ADMIRAL

CHASSIS 3N1A, MODELS Y4049, Y4071, Y4072, Y4073

Schematic of 3N1A Stereophonic High Fidelity Amplifier Stamped Run 10.

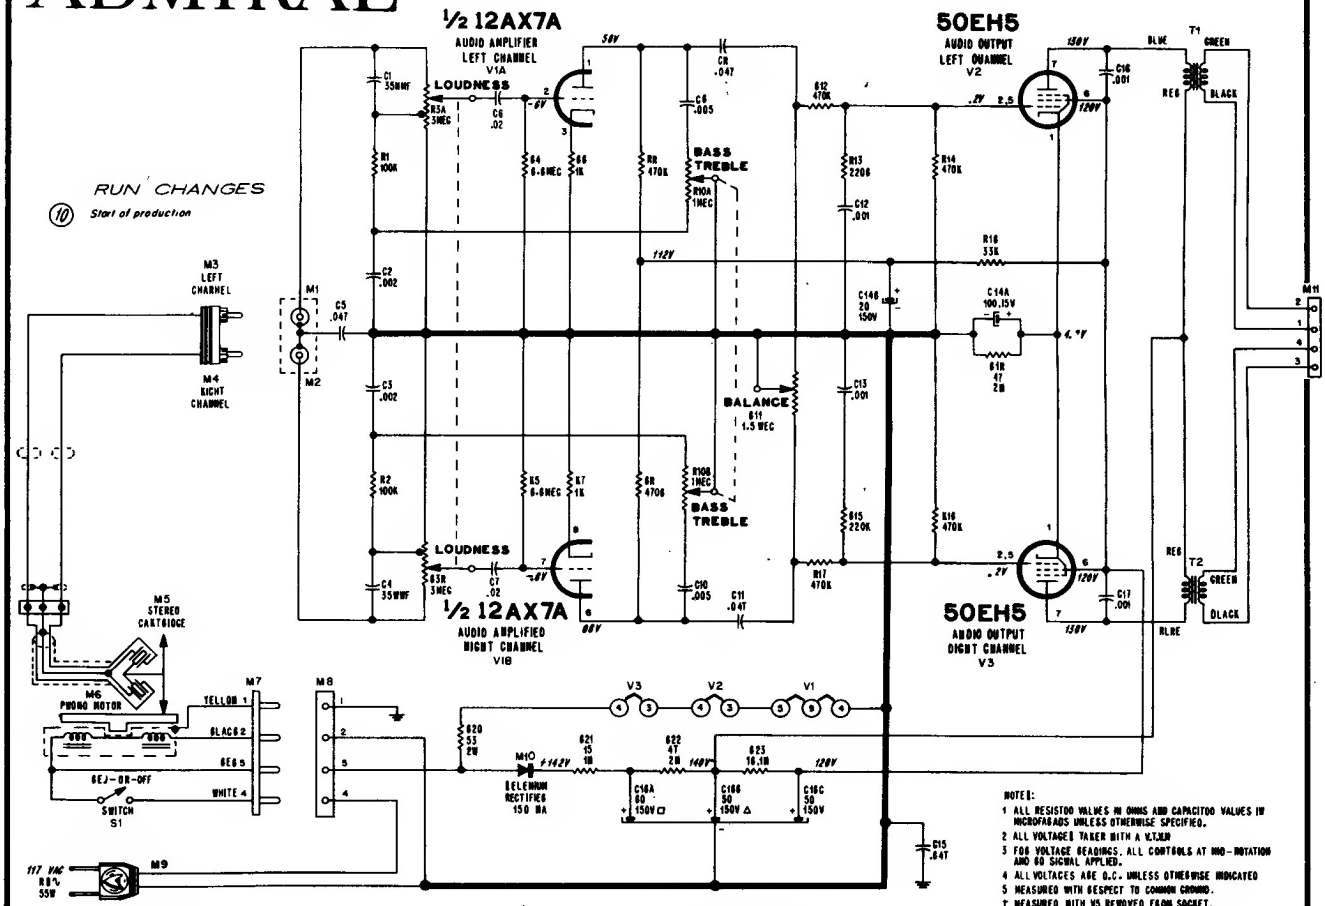
RUN 11 In All Sets
To improve performance (tonal quality) at low volume level, resistors R1 and R2 were changed from 100,000 ohms to one megohm, one-half-watt.
